關於：大埔第九區項目跟進查詢

立法會議員朱凱迪 謹啟

2017年3月24日

**Table 5.3 Proposed Public Transport Service in TP9 PTT**

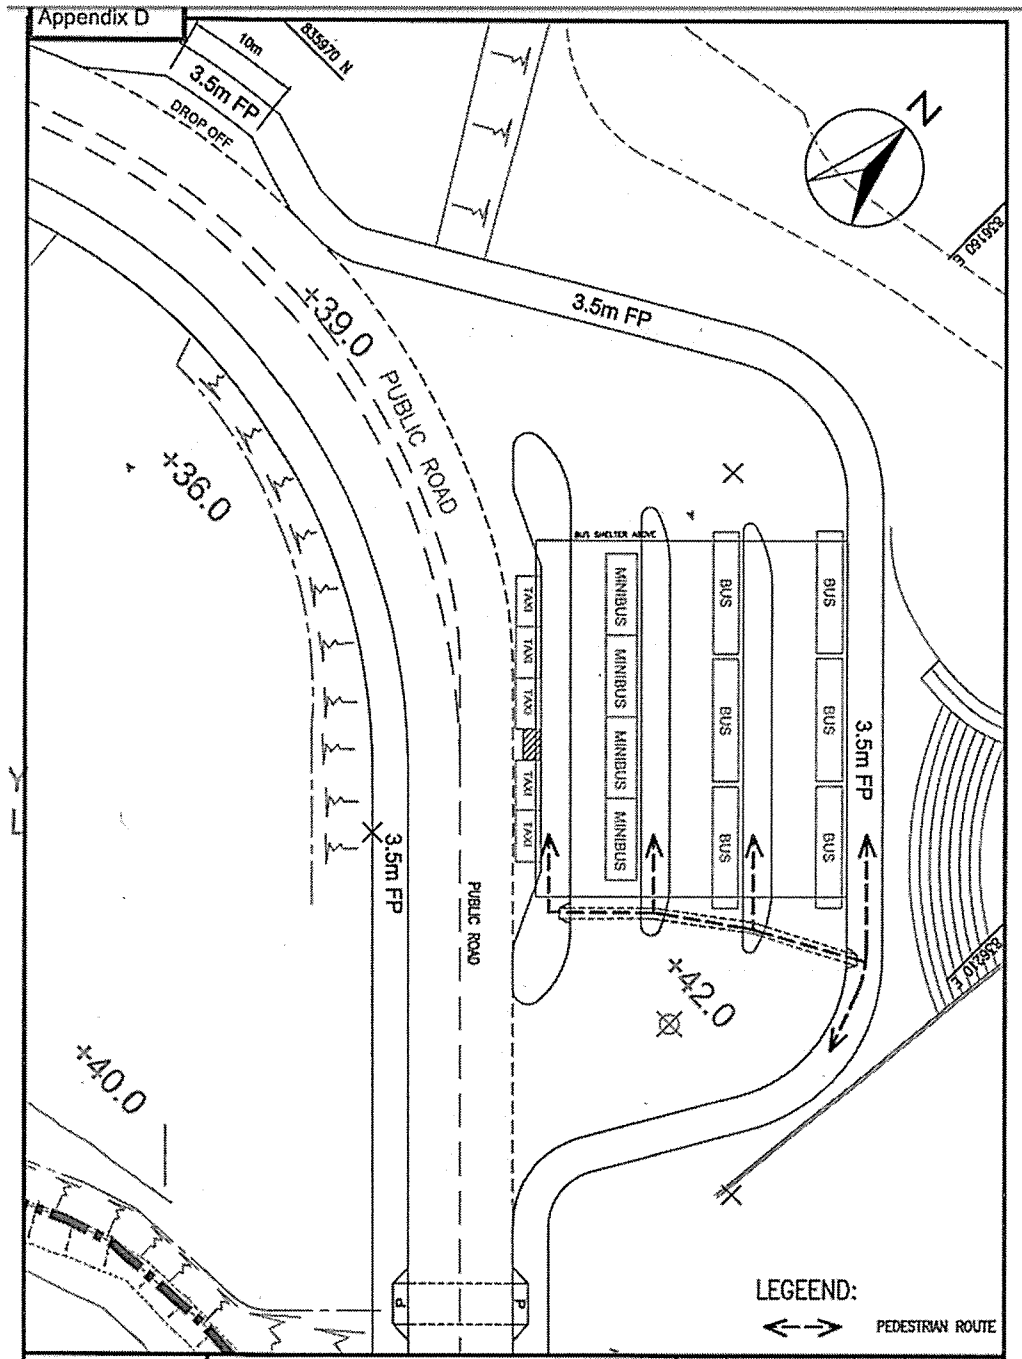
請說明，「每小時 4,320 人」是否意味，早上時段，離家出門人口為 4320 人 x2=8,640 人？此 8,640 人，除第九區外，是否包括同時服務頌路東西的居民？此 8,640 人，佔預計人口的百分之幾？數據基礎為何？
